## Assessment report to Sydney Central City Planning Panel

Panel reference: 2017SWC068

### Development application

<b>DA number</b>	SPP-17-00007	<b>Date of lodgement</b>	27 March 2017
<b>Applicant</b>	The Wickwood Property Group Pty Ltd		
<b>Owner</b>	R, M, E and M Haddad		
<b>Proposed development</b>	Construction of 2 residential flat buildings (8 storeys) comprising 170 apartments, 236 car parking spaces in 2 basement levels and associated civil and landscaping works		
<b>Street address</b>	Proposed Lot 1 in subdivision of Lot 74 DP208203 59 Cudgegong Road, Rouse Hill		
<b>Notification period</b>	23 July to 6 August 2018	<b>Number of submissions</b>	1 (in support)

ISSUE:  
**F**  
SHEET :  
**DA-A205**

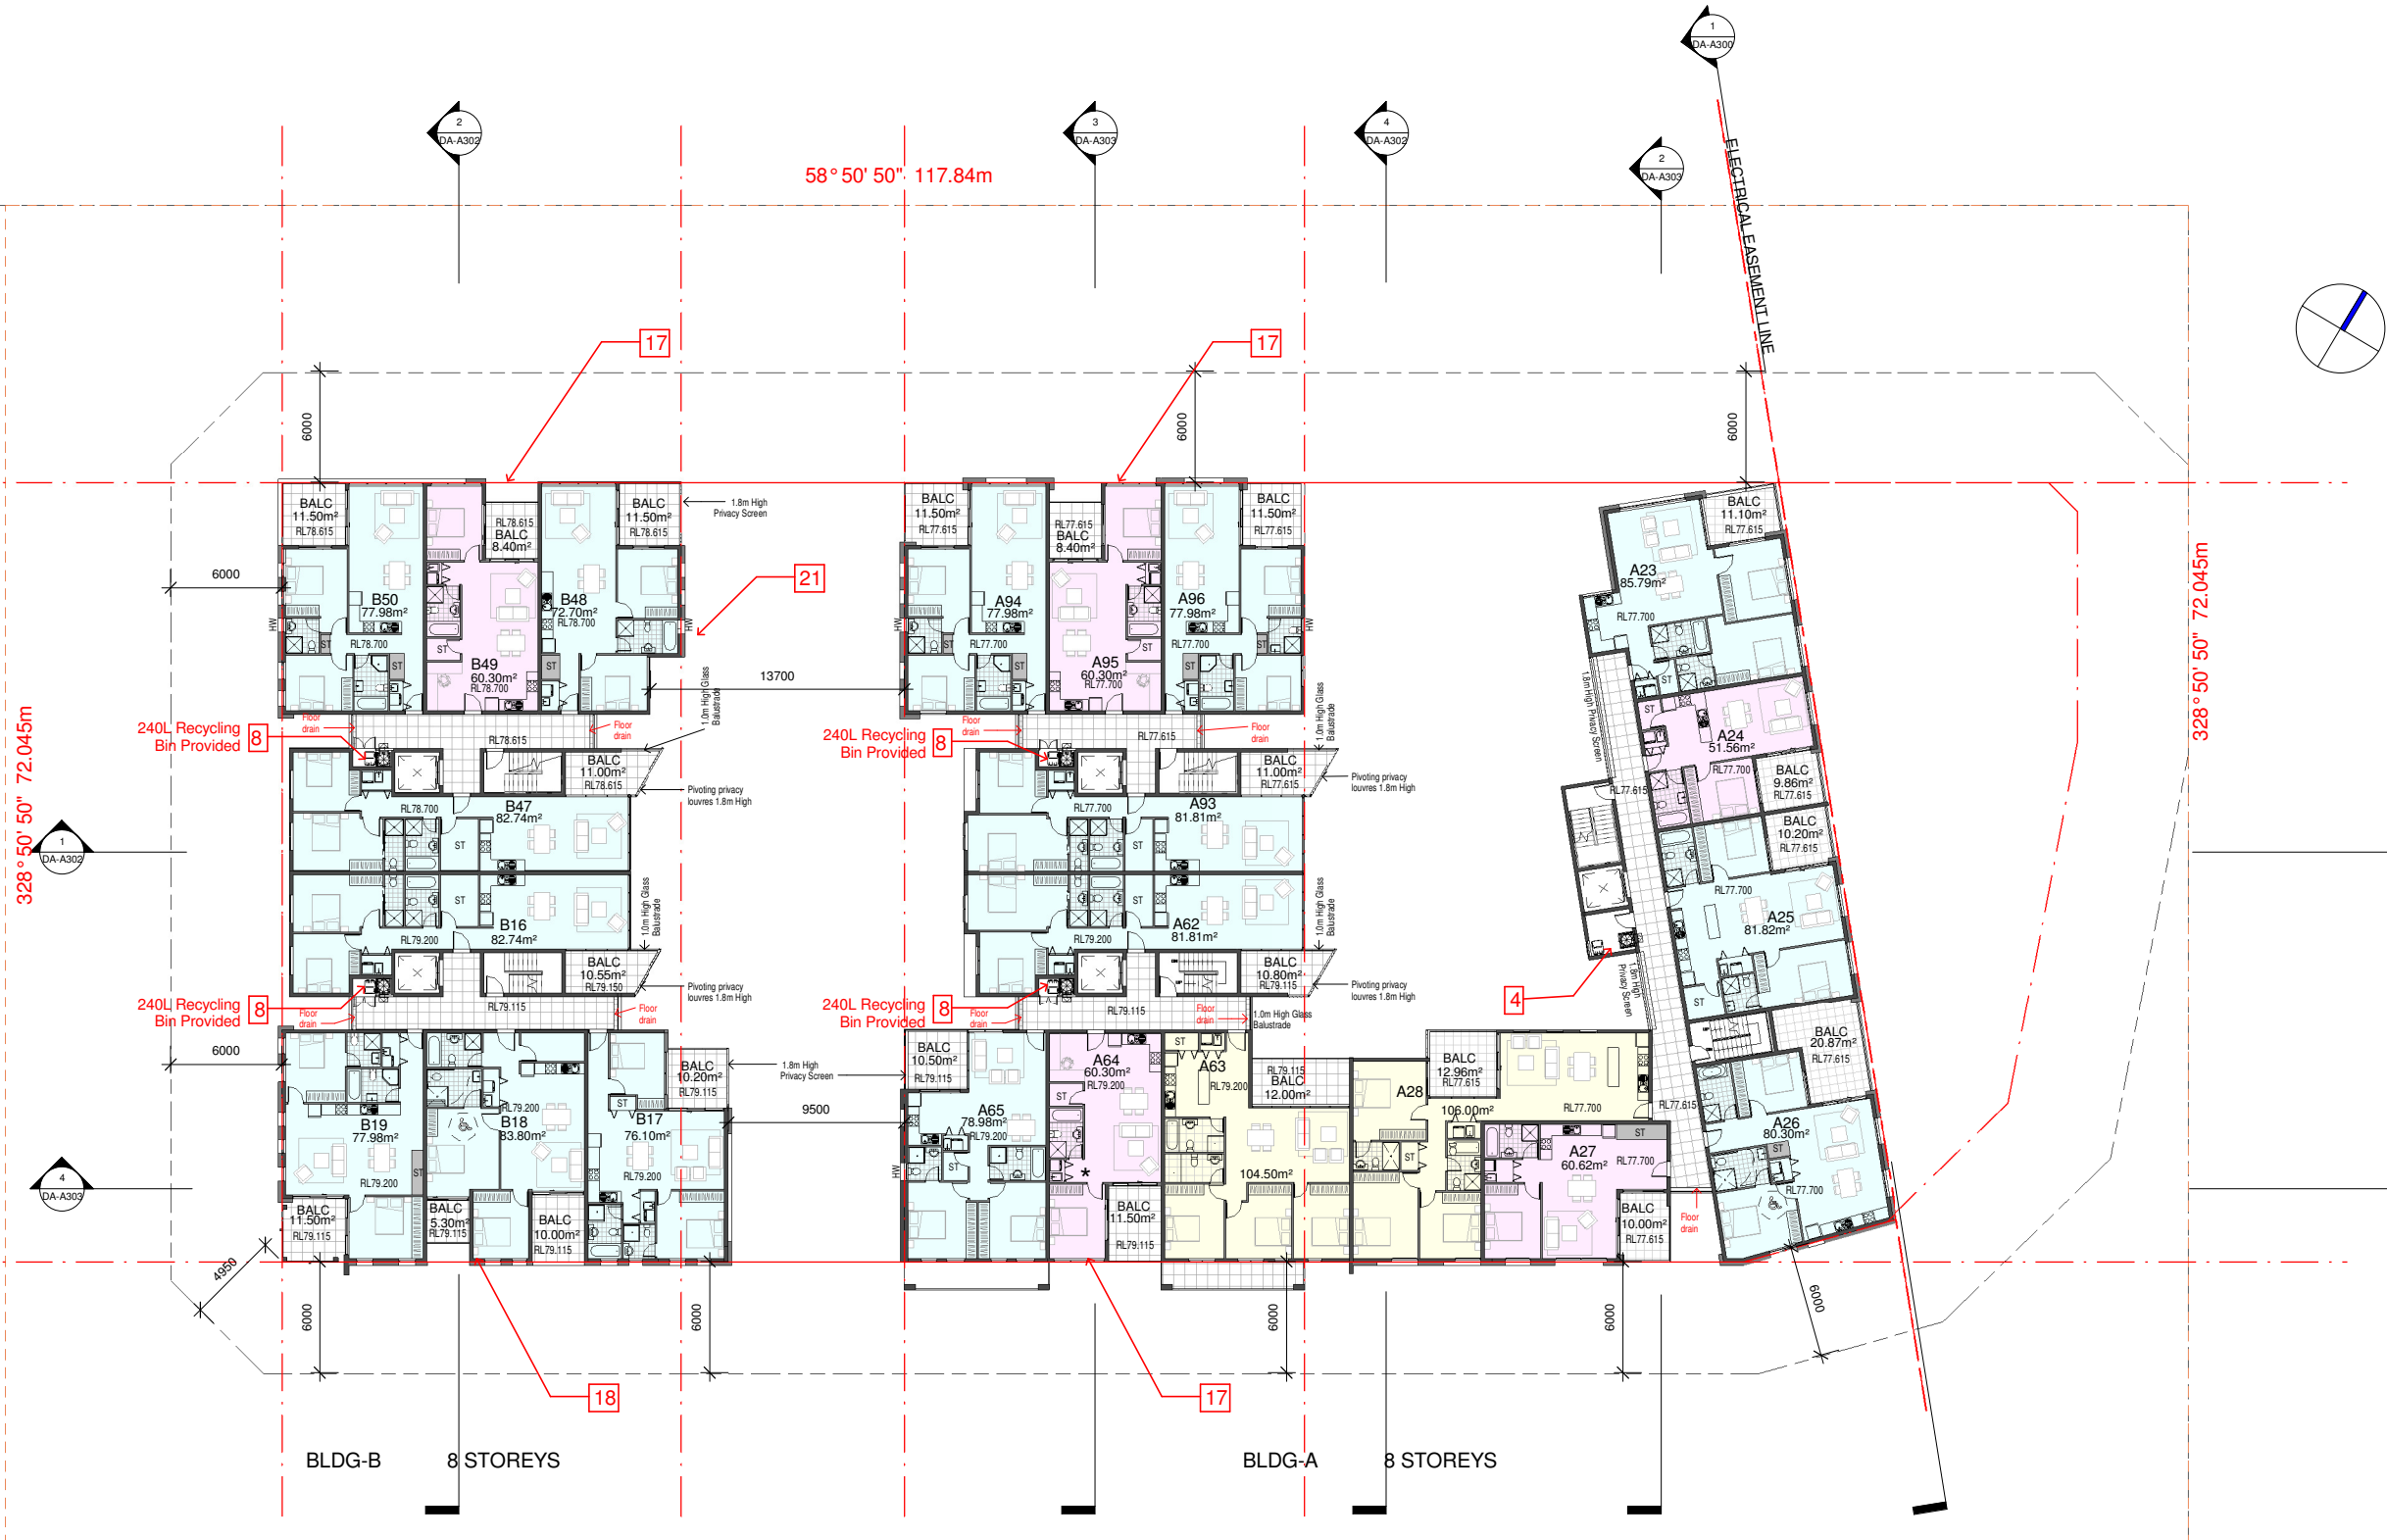
- 4.Building-A residents access to recycling bins located at the top of the stair well and adjacent to the lift core from Level 1 and above added.
- 5.Waste room access adjacent to the driveway ramp relocated.

- 16.Redesigned Building A to achieved solar access requirements to the communal open space. Fire stairs and lift relocated,access ramp added to access COS and redesigned of the unit layouts.

- 19.Building A roof plan adjusted and roof overhang deleted.
- 20.Skylights provided on Unit A45,A76,A77,B30& B31 but is not included in the solar calculation that recieved minimum 2hrs of sunlight.

ISSUE:  
**F**  
SHEET :  
**DA-A207**

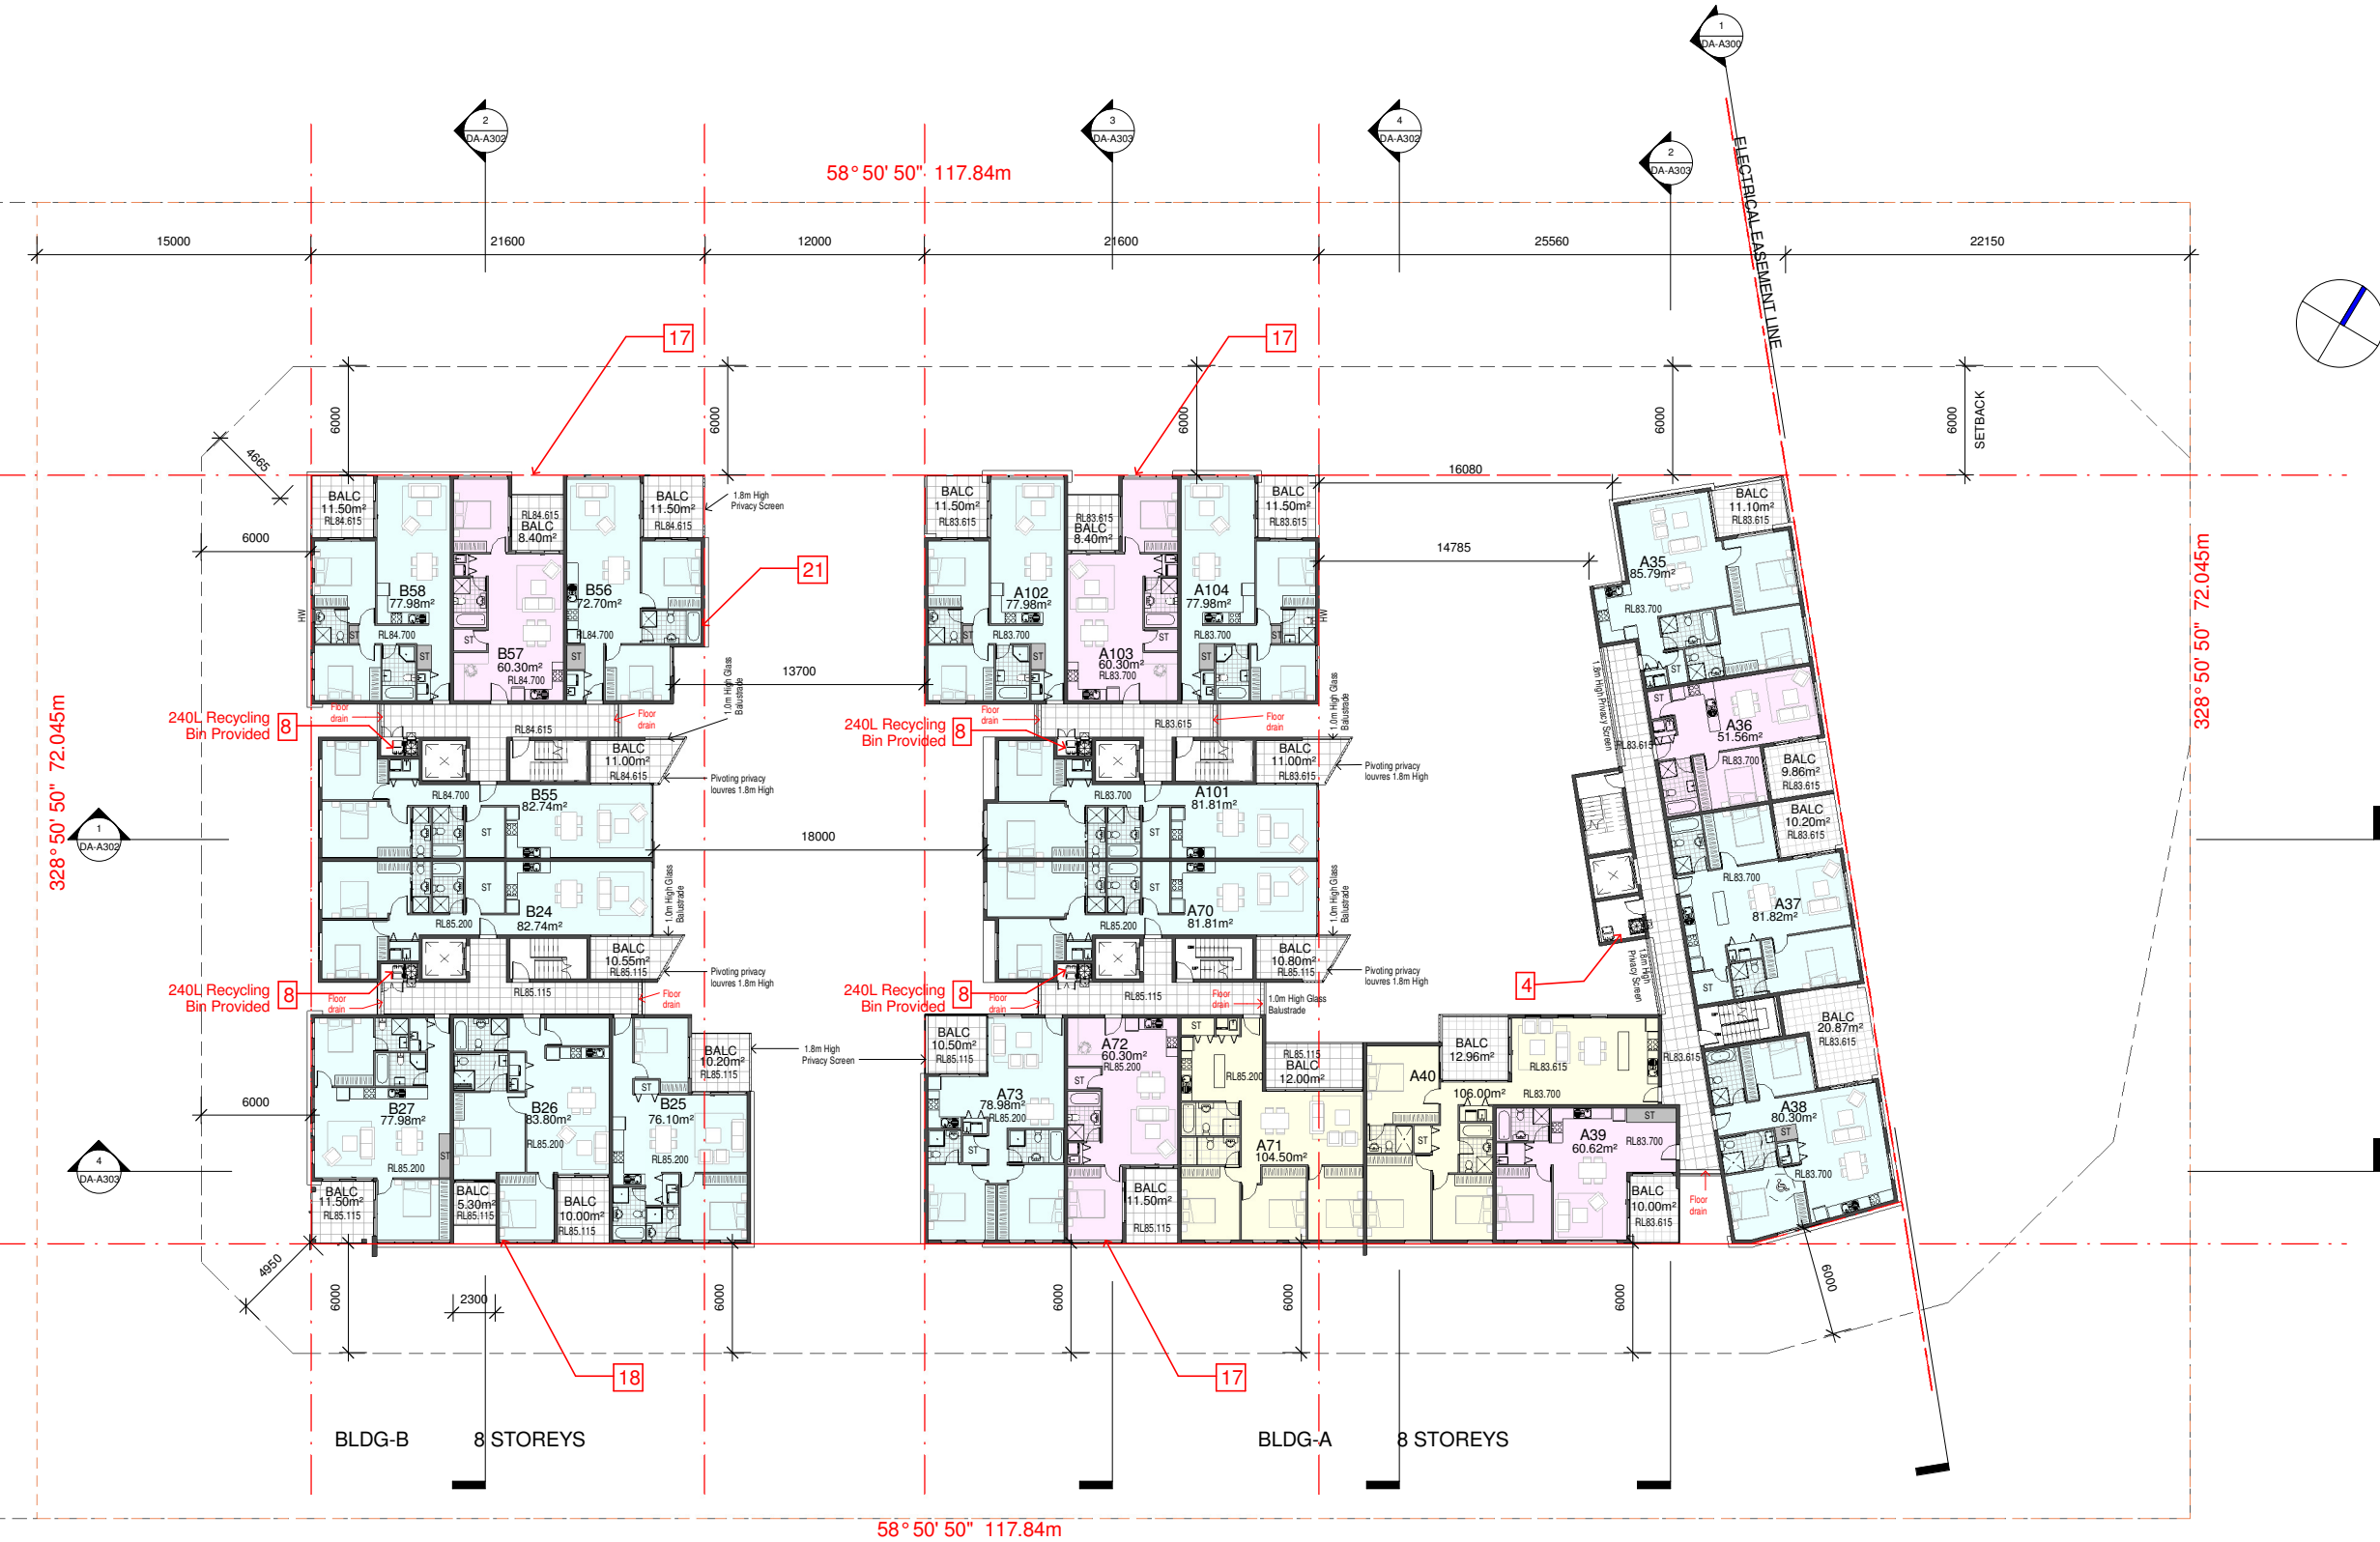
- 4.Building-A residents access to recycling bins located at the top of the stair well and adjacent to the lift core from Level 1 and above added.
- 5.Waste room access adjacent to the driveway ramp relocated.

- 16.Redesigned Building A to achieved solar access requirements to the communal open space. Fire stairs and lift relocated,access ramp added to access COS and redesigned of the unit layouts.

- 19.Building A roof plan adjusted and roof overhang deleted.
- 20.Skylights provided on Unit A45,A76,A77,B30& B31 but is not included in the solar calculation that recieved minimum 2hrs of sunlight.
